In re PATENT APPLICATION OF
UBER

Title: MULTI-PATIENT FLUID DISPENSING

PRELIMINARY AMENDMENT

FIG 8

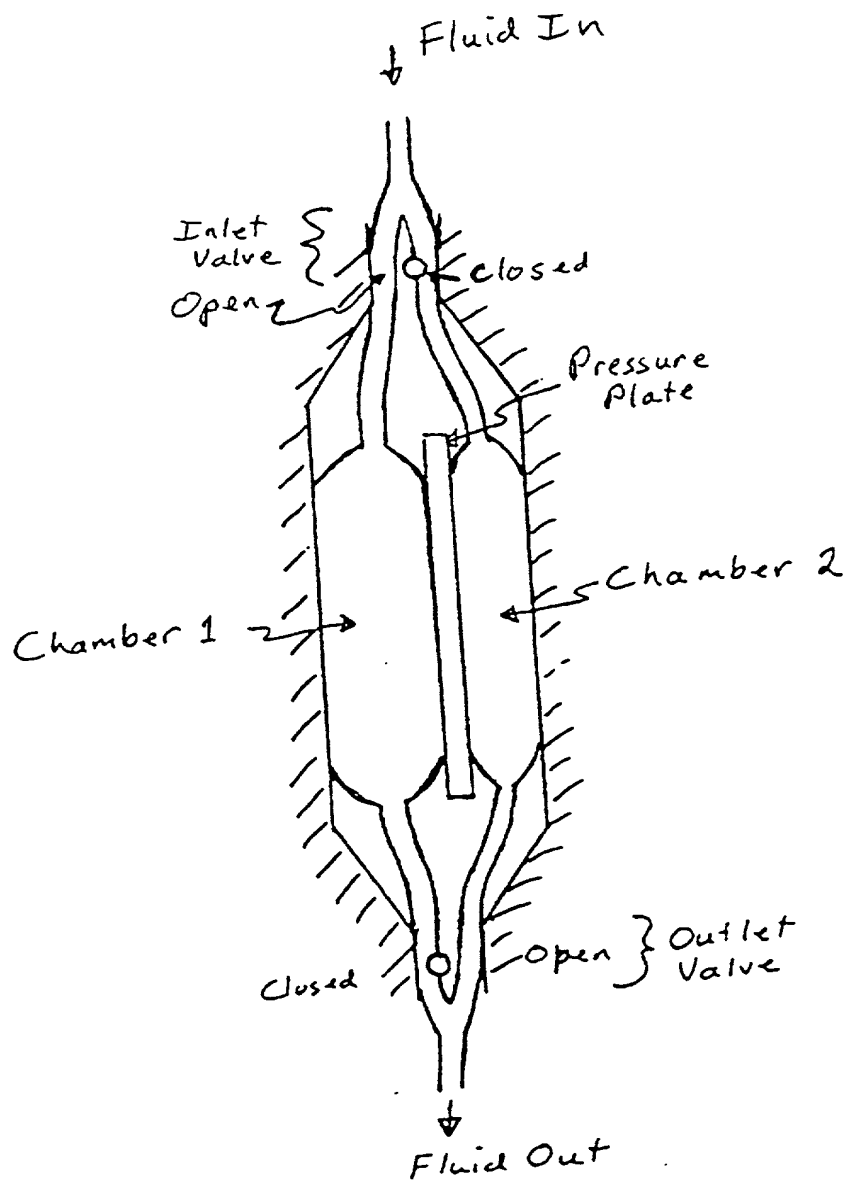
FIG. 8 shows another means of dividing the fluid flow into discrete packets to prevent cross-contamination. This is a variation on the peristaltic idea, where the fluid path splits into two parts. In this figure, fluid is flowing into inlet 6 of chamber 1, its outlet 7 is blocked so the chamber expands and drives the pressure plate 3 against chamber 2. This drives fluid out of chamber 2 and on to the patient. When the pressure plate reaches the maximum designed travel, the inlet valve 4 and outlet valve 5 switch position, allowing chamber 2 to fill and chamber 1 to empty. This allows continuous fluid flow but never permits a continuously open fluid path to exist. It is preferred that the pressure plate upon reaching its end of travel mechanically trigger the inlet valves, and that there be a mechanical linkage between the valves so that they can not both simultaneously open to the same chamber. These controlling strategies could also be performed by the ECS, with redundancy and verification of valve positions. It is possible to extend this concept to using three or ore chambers, to get a more even flow.

FIG. 8 shows another means of dividing the fluid flow into discrete packets to prevent cross-contamination. This is a variation on the peristaltic idea, where the fluid path splits into two parts. In this [picture] figure, fluid is flowing into inlet 6 of chamber 1, [it's outlet] its outlet 7 is blocked so the chamber expands and drives the pressure plate 3 against chamber 2. This drives fluid out of chamber 2 and on to the patient. When the pressure plate reaches the maximum designed travel, the inlet valve 4 and outlet valve[s] 5 switch position, allowing chamber 2 to fill and chamber 1 to empty. This allows continuous fluid flow but never permits a continuously open fluid path to exist. It is preferred that the pressure plate upon

FIG 10

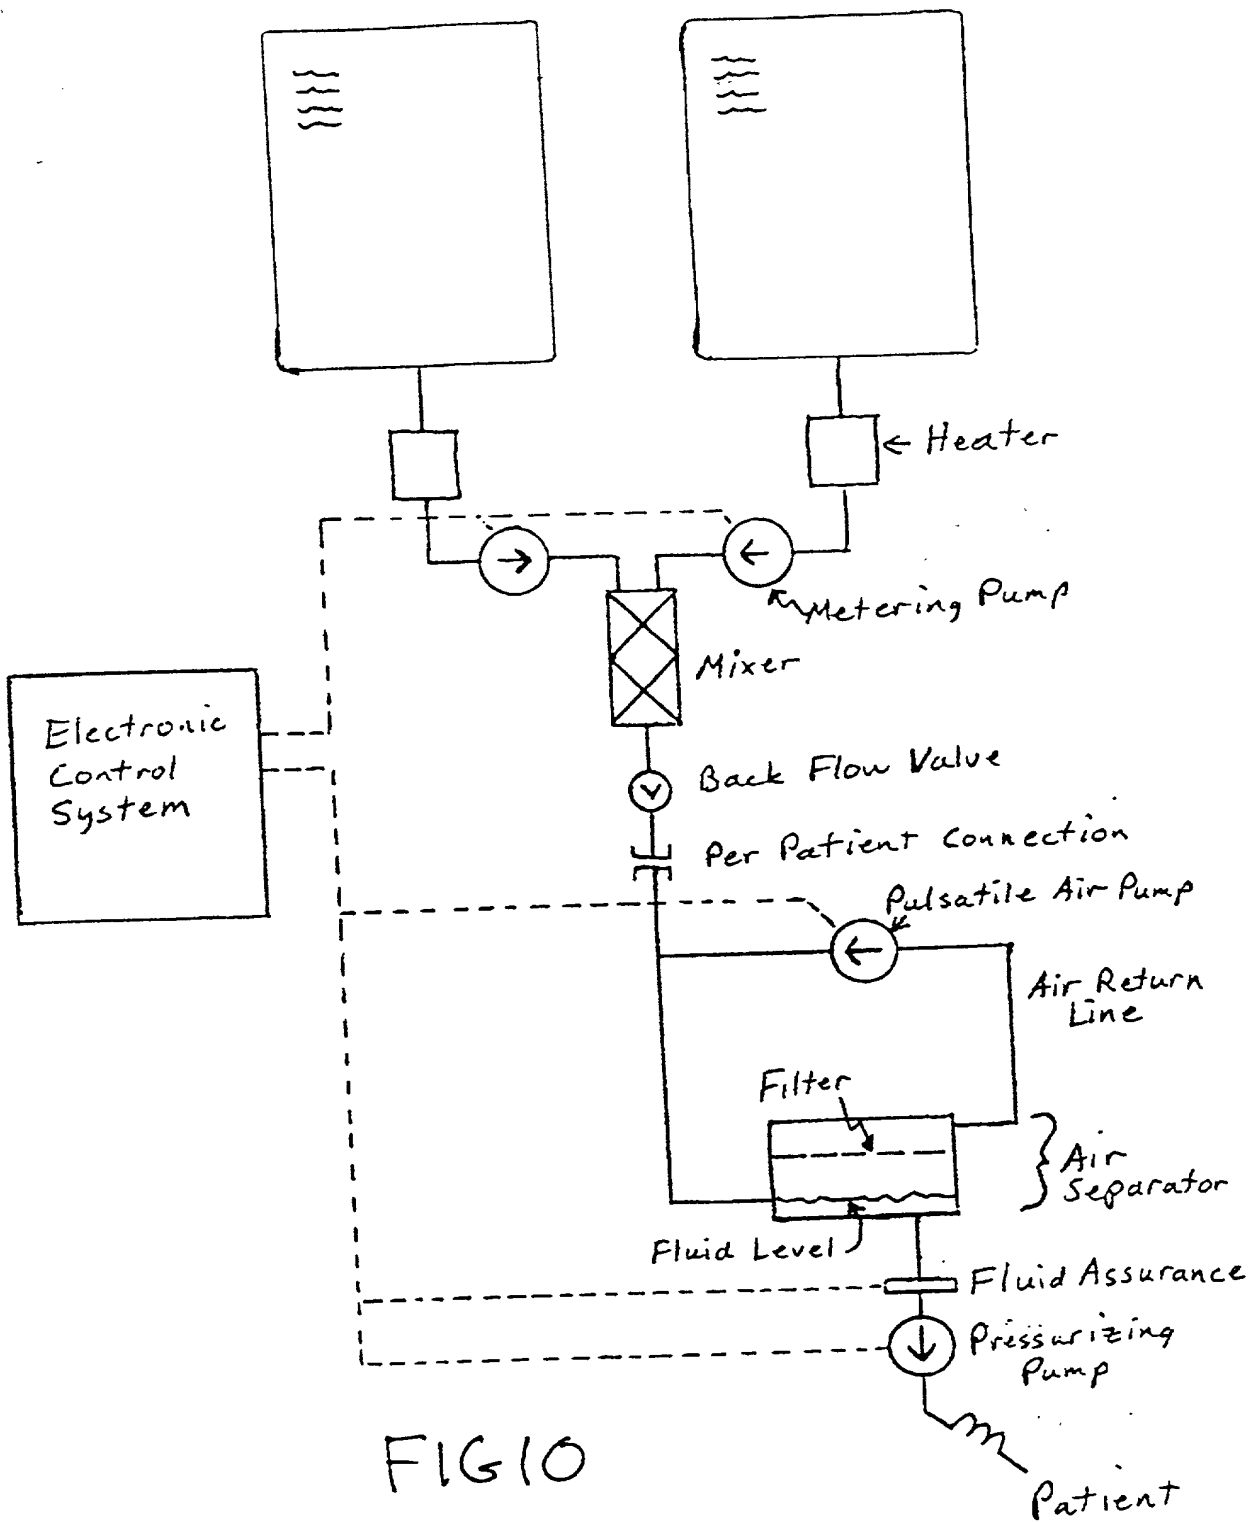
FIG. 10 shows another implementation of packetizing of the fluid flow. In this embodiment it is accomplished via air separation rather than via an intervening solid. After the fluids are mixed, they flow through a back flow valve 23. The fluid then flows through a “y” where it is mixed with packets of air. The air packets separate fluid packets, preventing back diffusion or migration of contaminants if the flow slows or stops. The wall material and

diameter of the tubing is chosen so that the air packets are stable. During operation, fluid and air flow down the line to the air separating chamber 24. Here air separates itself from the fluid and moves upward through a filter 37, returning to be used again. Fluid 38 flows on to the pressurizing pump. The pulsatile air pump 28 could be a peristaltic pump, possibly operating out of phase with the fluid metering pumps so that air is injected when liquid flow is minimum from the metering pumps. After the air is separated from the liquid, the liquid flows through a fluid assurance device 29, is pressurized by the pressurizing pump 33 and flows into the patient 34. The ECS will stop the pumping if the fluid assurance detector detects any air in the line to the pressurizing pump. All of the tubing down stream from the "per patient" connector 39 is disposed of after each patient. If the flow from the metering pumps is sufficiently pulsatile, it may not be necessary to have the air pump. The momentum of flowing fluid can be sufficient to entrain packets of air between packets of fluid.

FIG. 10 shows another implementation of packetizing of the fluid flow. In this embodiment it is accomplished via air separation rather than via an intervening solid. After the fluids are mixed, they flow through a back flow valve 23. The fluid then flows through a “y” where it is mixed with packets of air. The air packets separate fluid packets, preventing back diffusion or migration of contaminants if the flow slows or stops. The wall material and diameter of the tubing is chosen so that the air packets are stable. During operation, fluid and air flow down the line to the air separating chamber 24. Here air separates itself from the fluid and moves upward through a filter 37, returning to be used again. Fluid 38 flows on to the pressurizing pump. The pulsatile air pump 28 could be a peristaltic pump, possibly operating out of phase with the fluid metering pumps so that air is injected when liquid flow is minimum from the metering pumps. After the air is separated from the liquid, the liquid flows through a fluid assurance device 29, is pressurized by the pressurizing pump 33 and flows into the patient 34. The ECS will stop the pumping if the fluid assurance detector detects any air in the line to the pressurizing pump. All of the tubing down stream from the “per patient” connector 39 is disposed of after each patient. If the flow from the metering pumps is sufficiently pulsatile, it may not be necessary to have the air pump. The momentum of flowing fluid can be sufficient to entrain packets of air between packets of fluid.
